WORKSHOP AGENDA

Planning Commission

July 11, 2023 @ 5:30 PM

Item Title: Site Plan - Marlowe La Vergne - 376 Apartments on 27.49 Acres. Requested by Kimley Horn. Property located at 243 Blair Road (Tax Map 32, Parcel 6). R-3 (High Density Residential) Zoning District. Property owned by Martin Shofner.

V-1.00

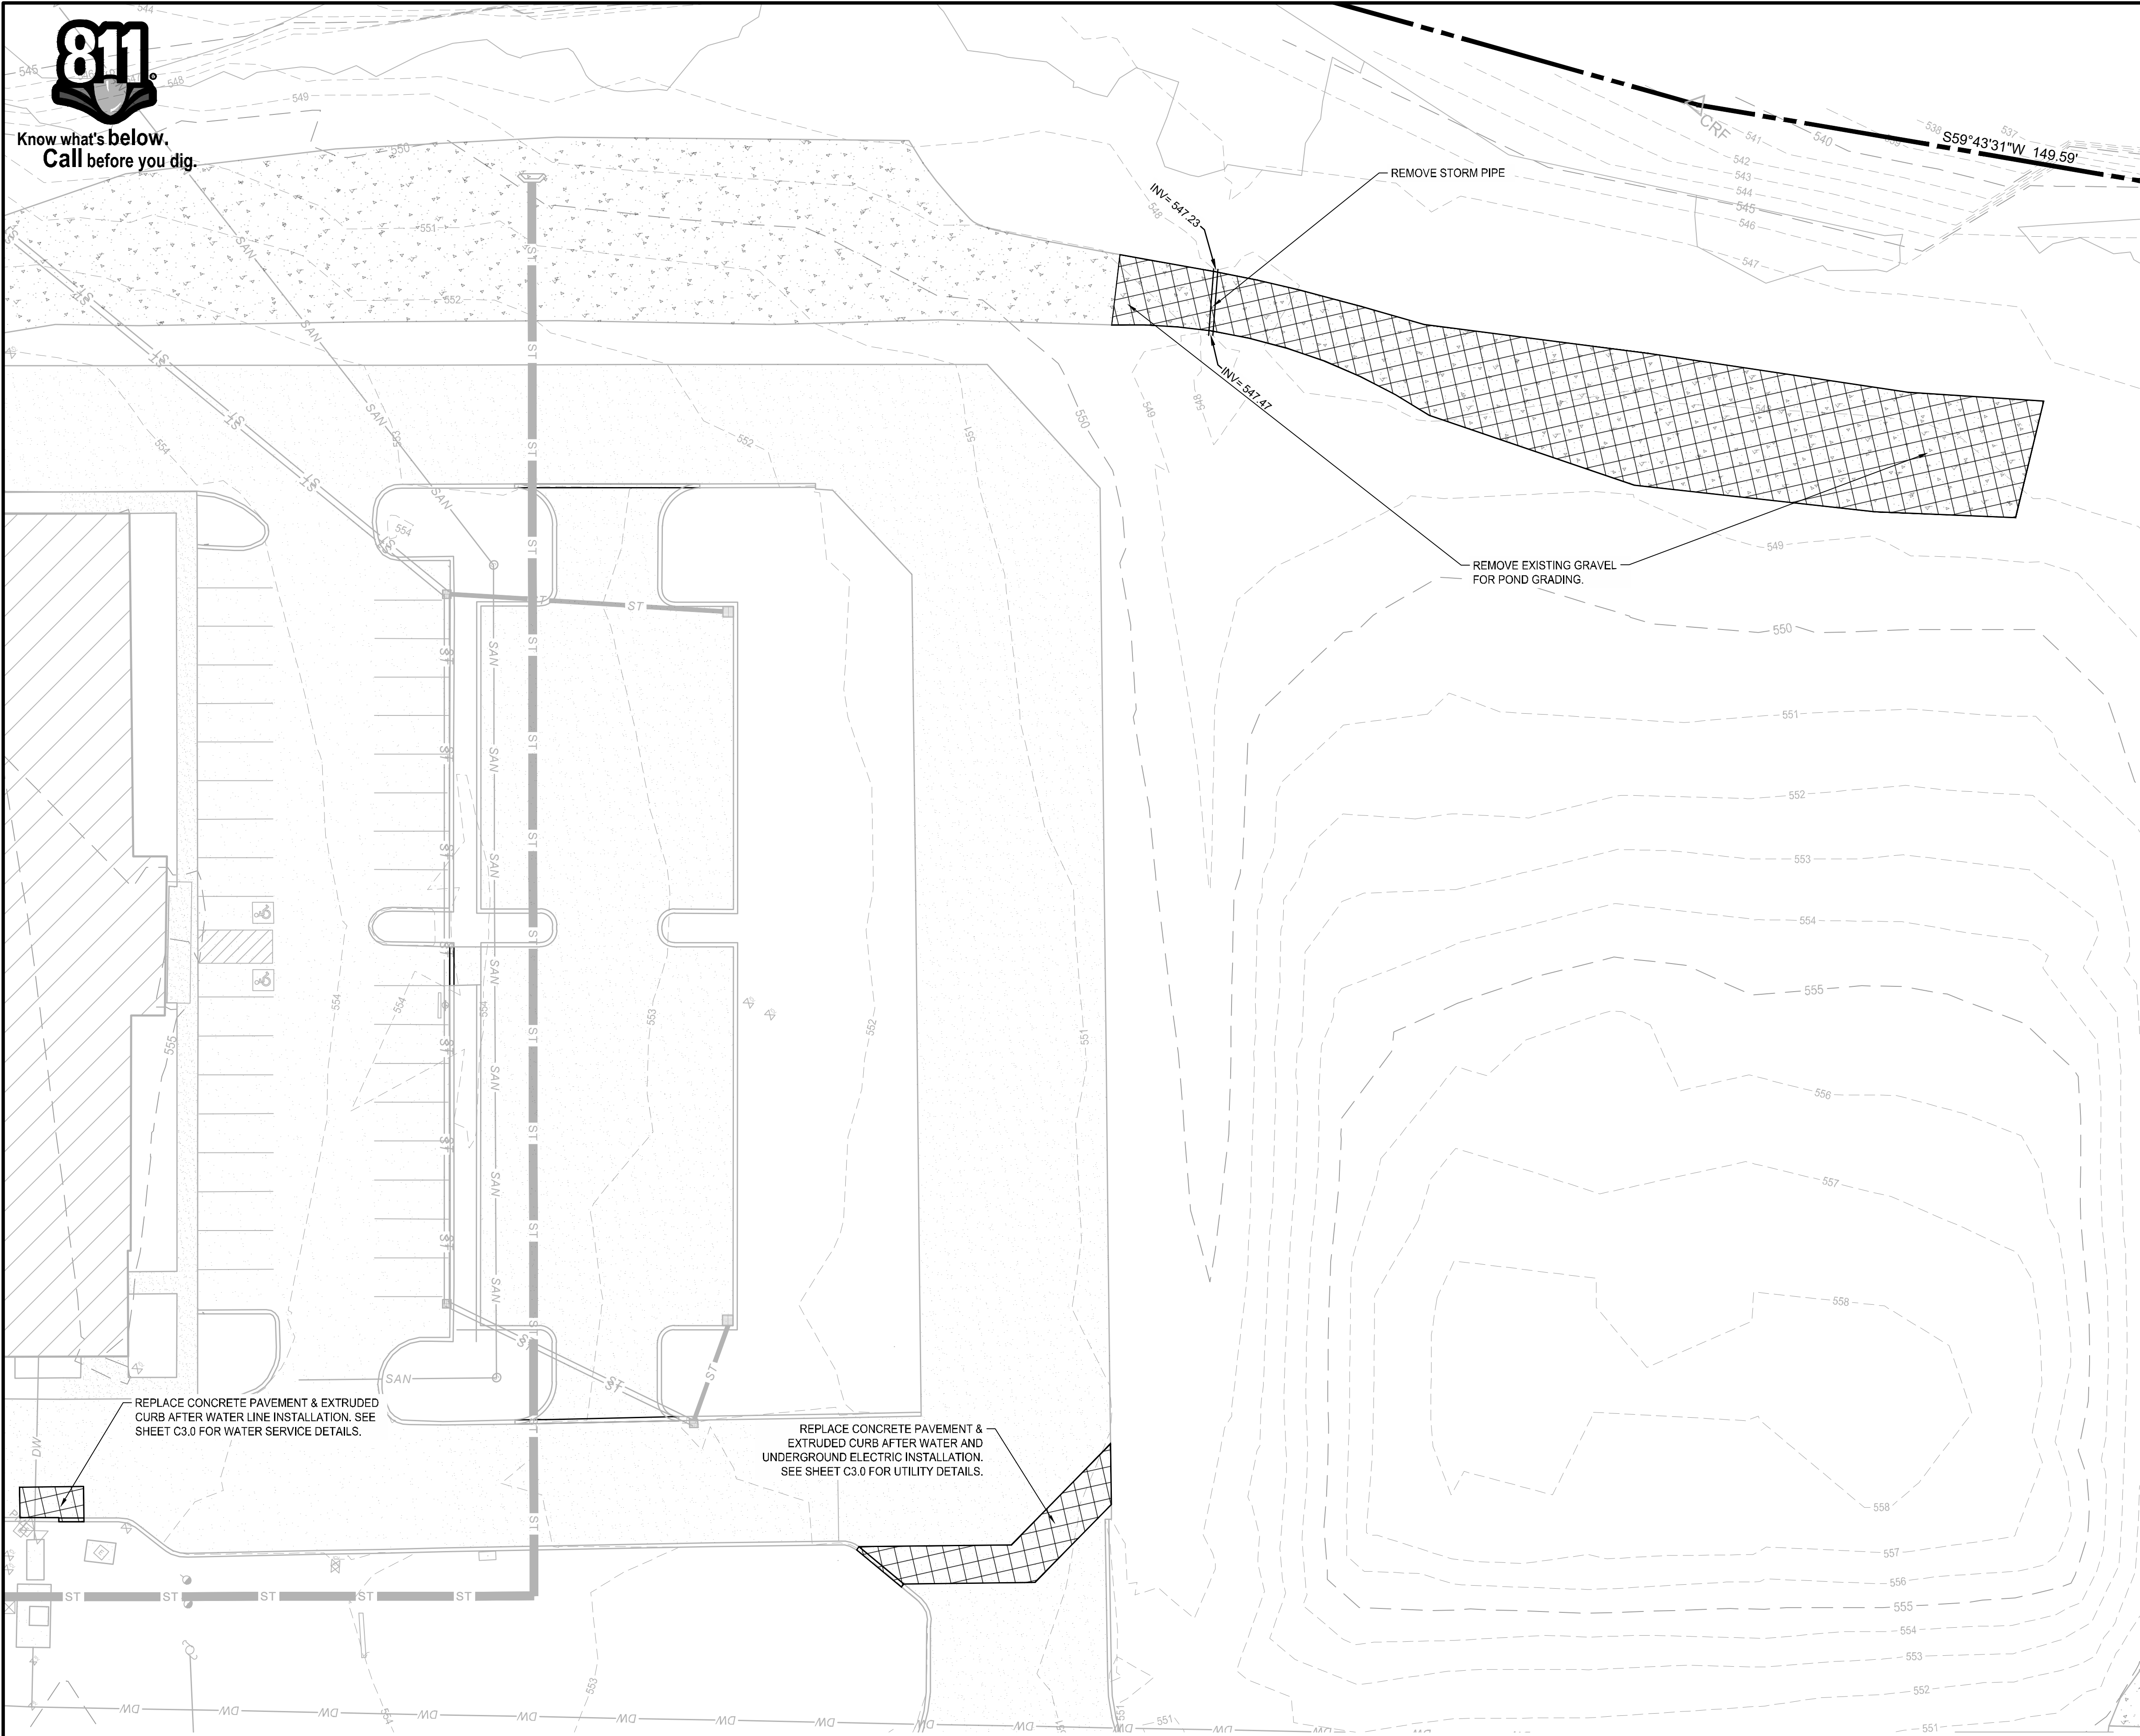
1. Sheet V-1.00 is double printed and very hard to read
2. On Sheet C2.1, provide erosion control matting in the swale created southeast of the building (Waldron Road side) by the intersection of the fill material with the existing slope.
3. On Sheet C2.1, provide a riprap pad to protect the slope transition of the swale south of the building to

C0.2

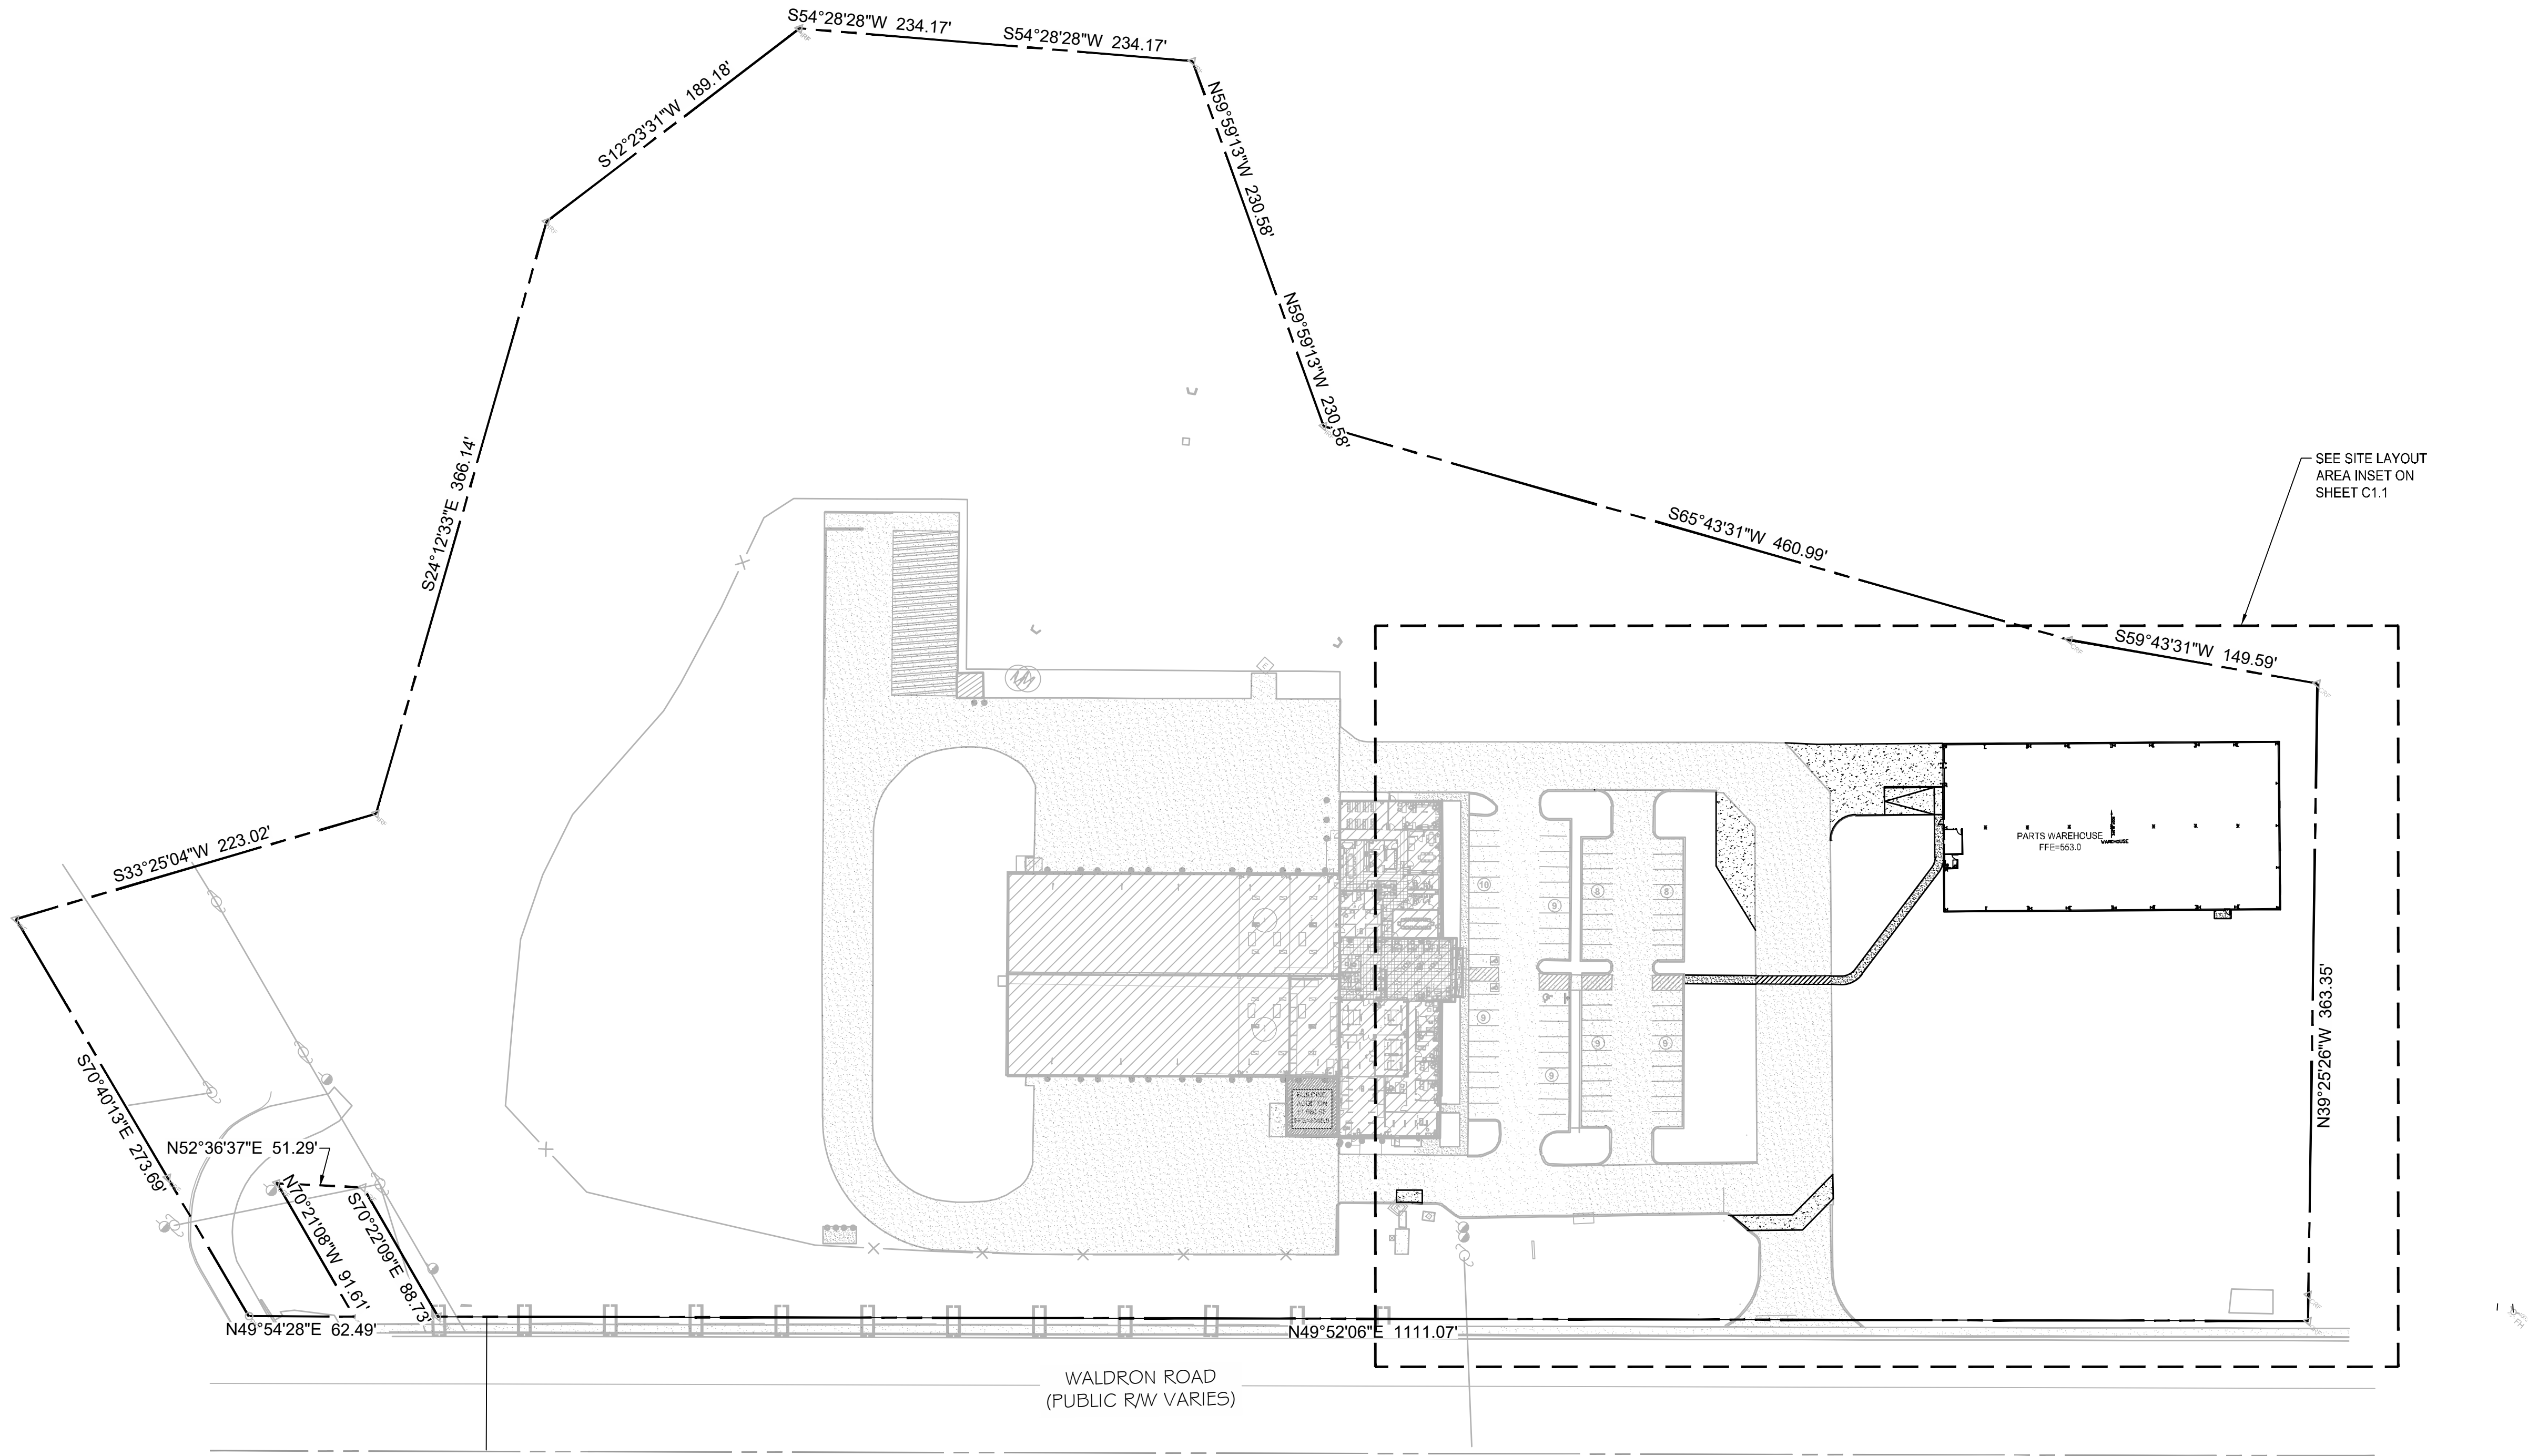
6. On Sheets C0.2 and C2.1, add detail regarding how construction traffic will be directed on construction exit prior to leaving the work area.
7. On sheet C0.2, add silt fence completely around disturbed areas where endwalls are to be located outfalling toward the northwest property boundary (away from Waldron Road).

8. On sheet C0.2, show location of concrete washout. Note 6 is insufficient. Please provide a location on the plans.
9. (Sheet C2.1) Intermediate and Final EPSC plan cannot be on the same sheet. Note 5 is insufficient for handling the transition from intermediate to final. Please add a separate final EPSC sheet as required by ordinance and as noted previously.

C1.1

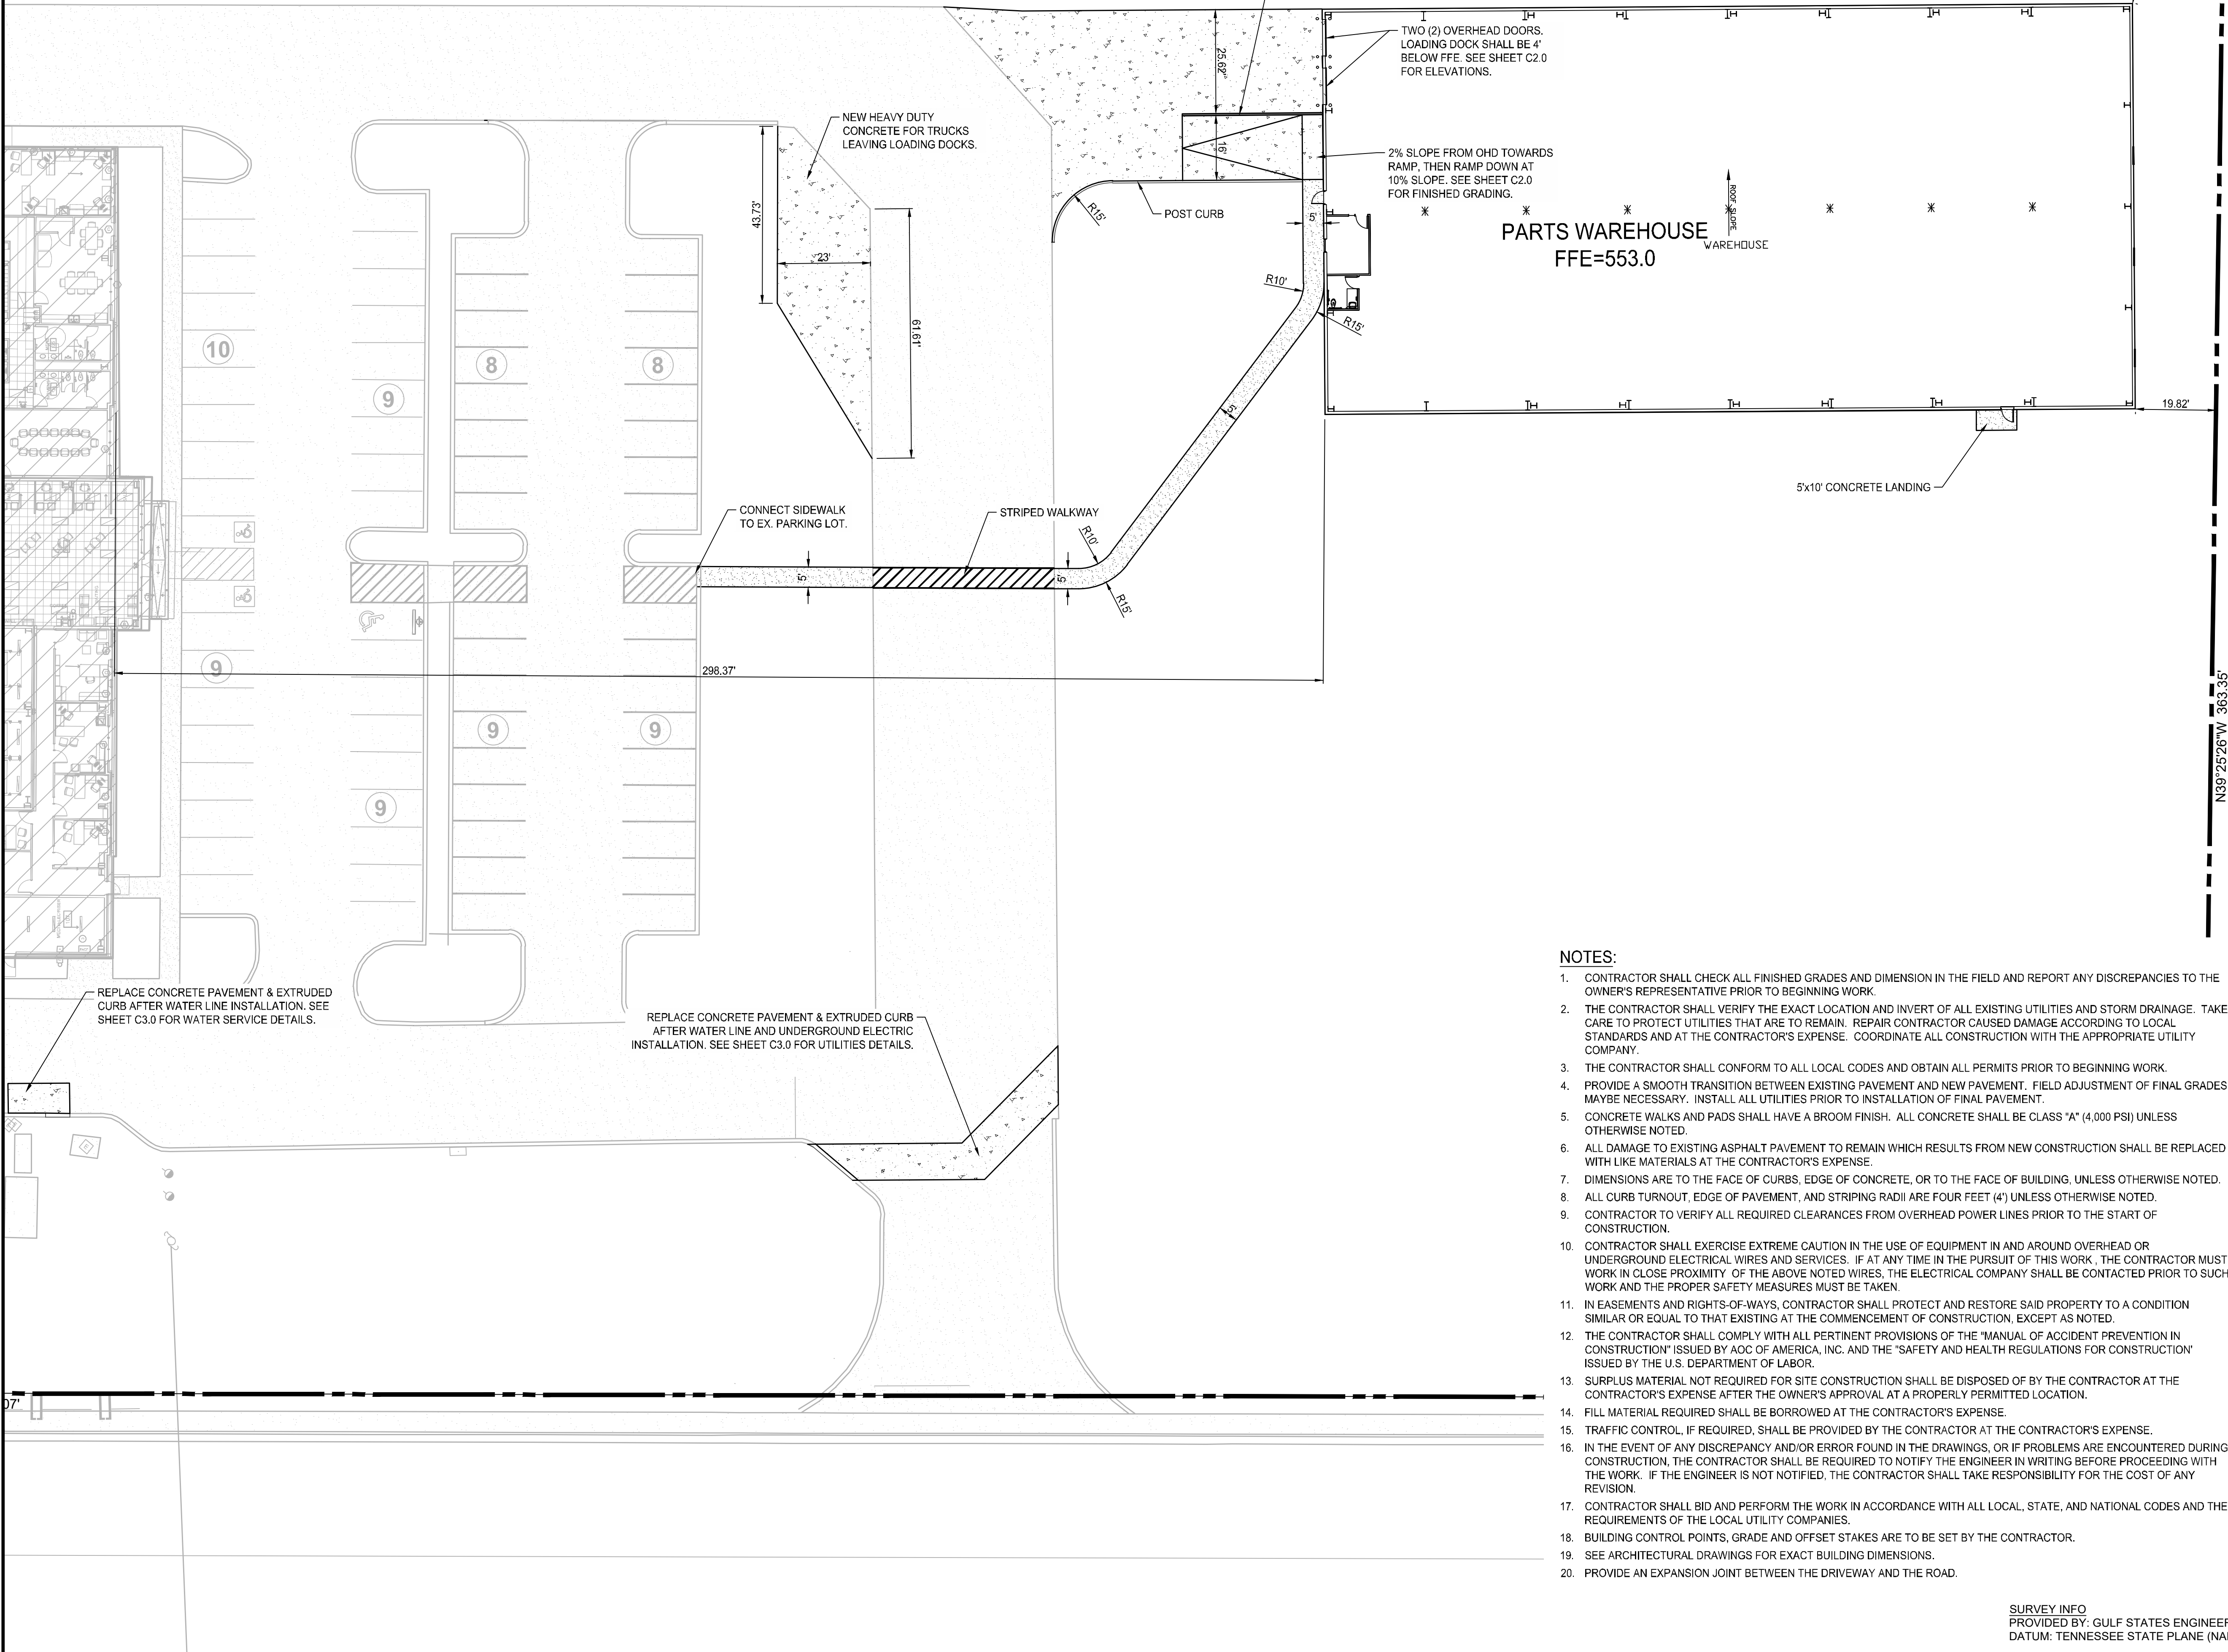
10. Either confirm that this building will not have an associated dumpster or provide location of dumpster and details for dumpster enclosure. If there is to be no dumpster, please add a note to sheet C1.1 stating that there will be no dumpster associated with this building.
